technical memorandum

TO William Dorset FROM Katy Grant
Pukerua Property Group LP DATE 6 August 2026
RE Mount Welcome Fast Track – Response to reviewer comments

2.1 Issue 2/Appendix 3 – Technical Comments Hydrology

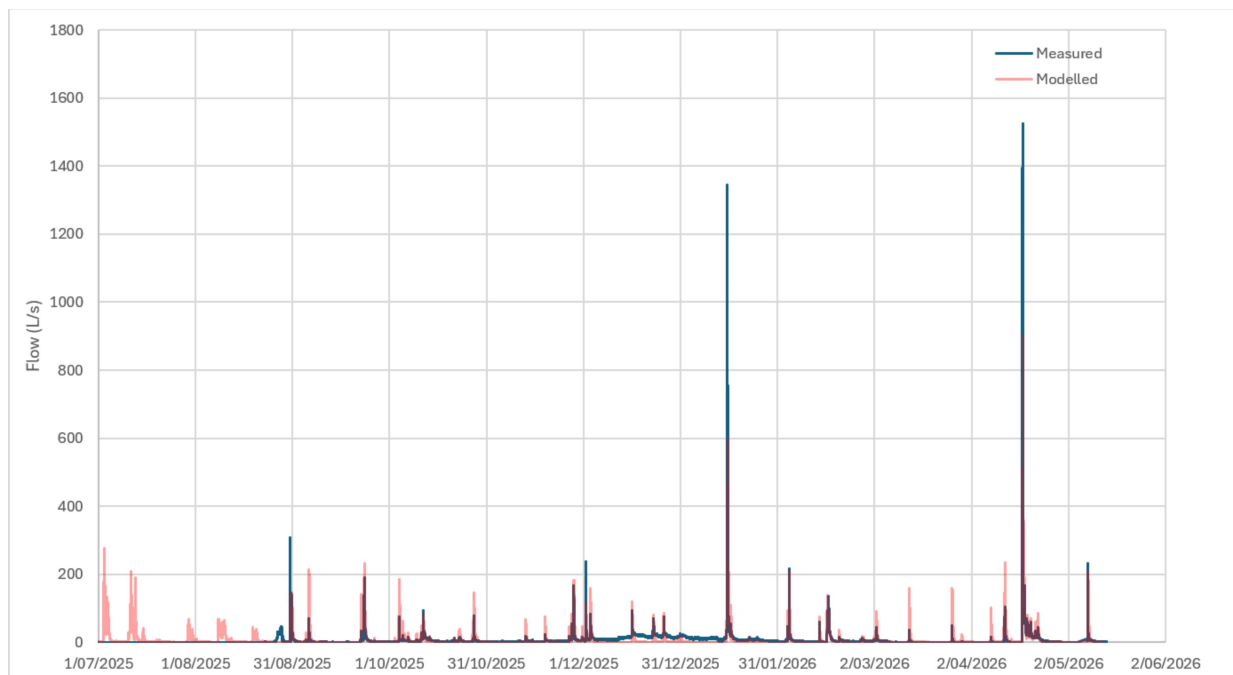
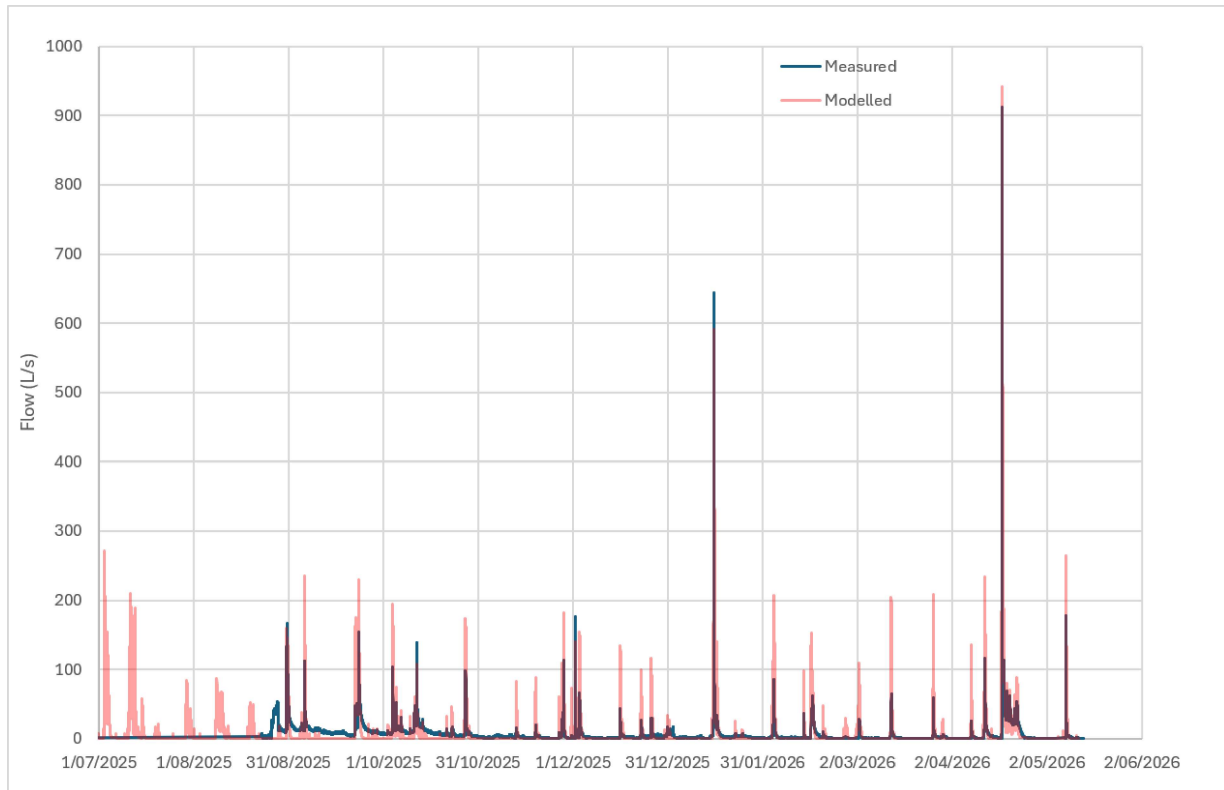
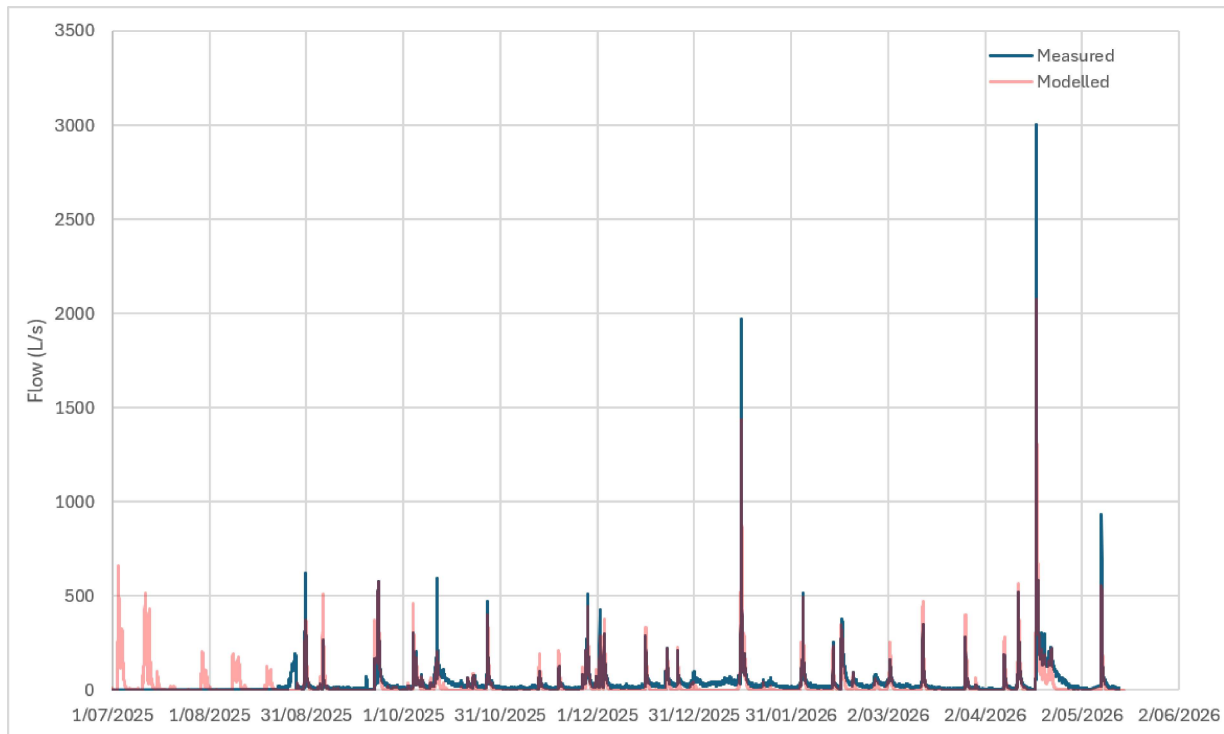
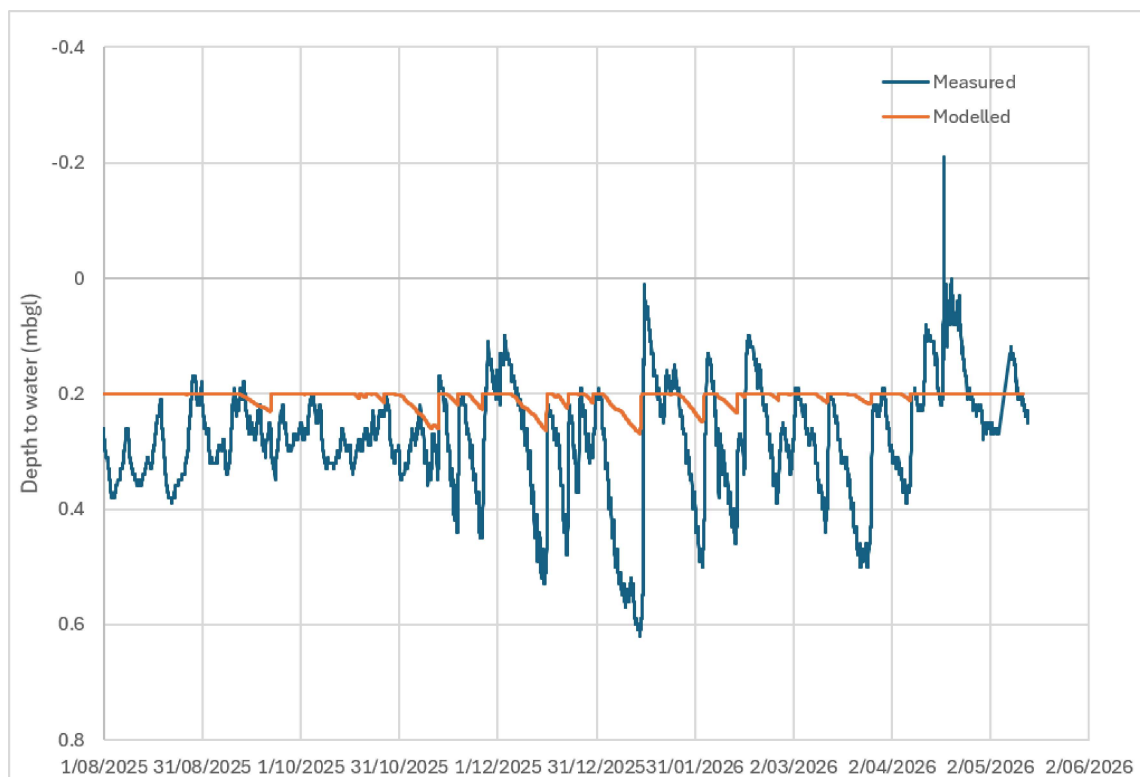
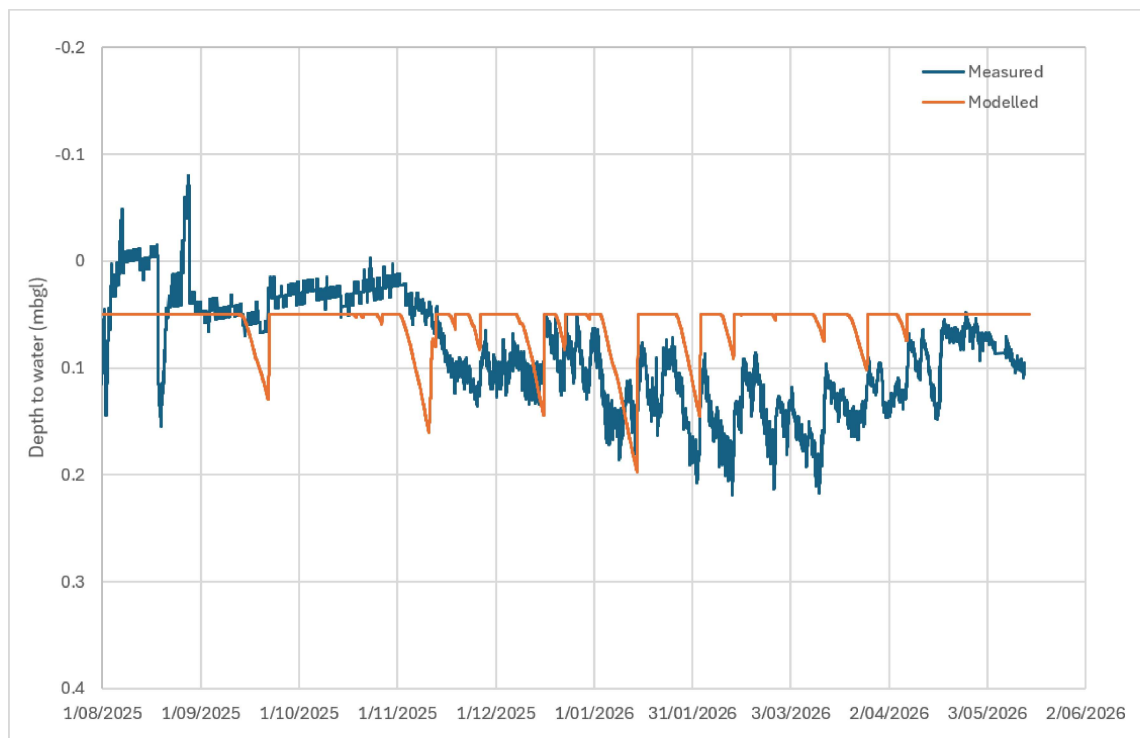
with the assumptions used to develop the model. However, as noted by the reviewer, the flows within the model are higher and have more peaks than the monitoring results indicate.

The model has therefore been recalibrated to the baseline data, and the results of this recalibration are presented here. Local rainfall and evapotranspiration data was run through the 5-minute timestep model for the period 1 June 2025 to 15 May 2026 and compared to the measured data. The 5-minute timestep was used to recalibrate to the flows estimated from the baseline data. It was necessary to slightly alter the run-off lag and downstream hydraulic conductivity values to better fit the data, see results in Figures 1 to 5 below.

The results indicate a good fit to flow in all three monitored catchments, although the model does underestimate the groundwater baseflow into the streams during winter periods in the Taupō Catchments and year-round in the Kakaho Catchment. The modelled wetland water levels exhibit less variability than the observed water levels, reflecting the model structure, which represent each wetland as a storage bucket with inflows and outflows, rather than a dynamic system with internal flow processes. This difference is particularly apparent in the T3 catchment, where the baseline monitoring results indicate that the wetlands can accommodate substantial water level fluctuations without adverse effects.

Furthermore, the monitoring points were not located within the centre of the wetland (to allow for long-term monitoring during and post development) so are likely to show more variation than would be measured centrally. Whilst the fit is not perfect, it is considered that the model provides a reasonable approximation of changes to the entire wetland, albeit not exactly matching localised variations.

Figure 10: Modelled pond volumes at Retention Wetland E

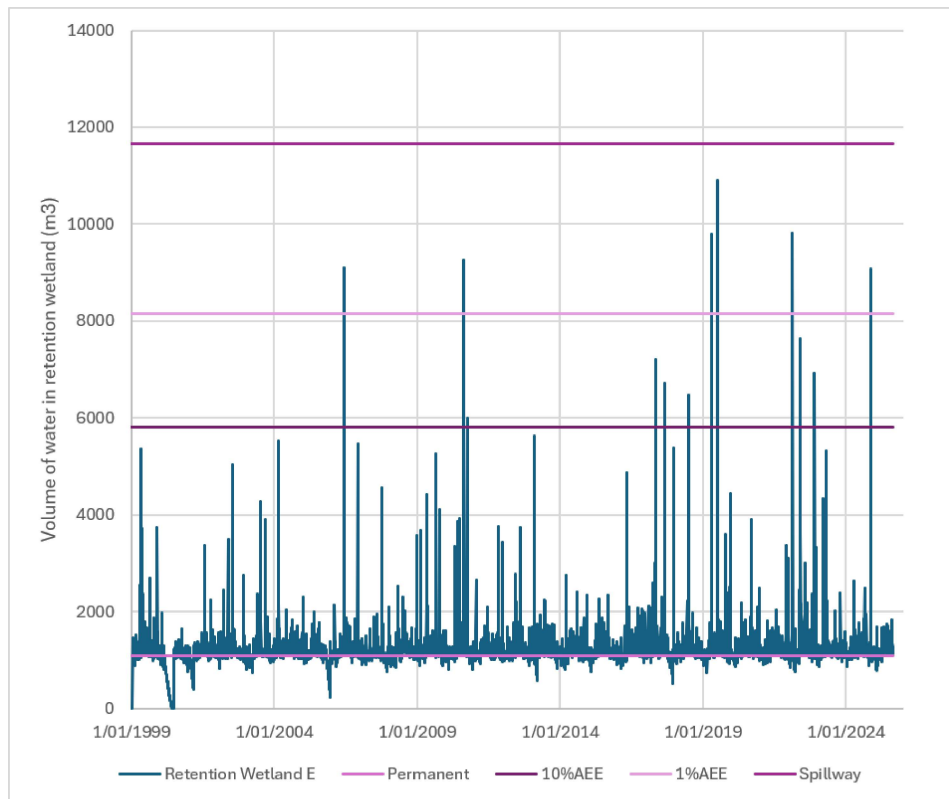
- A. Sediment retention in the wetlands and how this will be managed during and post construction.
- B. The duration of time the wetlands and streams may be off-line during construction.
- C. The depth of standing water within these wetlands and whether this will be sustainable from a wetland planting perspective.
- D. Water quality and fish passage issues associated with a standing water body within these wetlands when there are periods of no flow through the culvert outlets.

Regarding concerns around the periods of no flow through culvert outlets (point D), Figure 10 below indicates that there may be periods when the water level in Retention Wetland E (K1W4) will be lower than the culvert inlet (line marked permanent in figure). This is also true to a lesser extent for the retention wetlands (A, B and C) in the Taupō Catchment. The duration and extent of water level fluctuation is very sensitive to the hydraulic conductivity of soils downstream of the wetland, which are higher in the Kakaho Catchment due to the alluvial deposits present in this area.

It should be noted that this assessment is considered to be conservative as it underestimates the inflow of groundwater into the wetland and stream, see baseline calibration above. However, based on the modelling results, there may be periods when water does not flow through the culvert at Retention Wetland E. These periods are mostly concentrated in the summer months when it is understood from the project ecologist that fish passage is less critical. During winter months it is considered likely that higher groundwater levels will mean flow is more consistent, but based on the conservative model results, periods of no fish passage are usually less than 8 consecutive days.
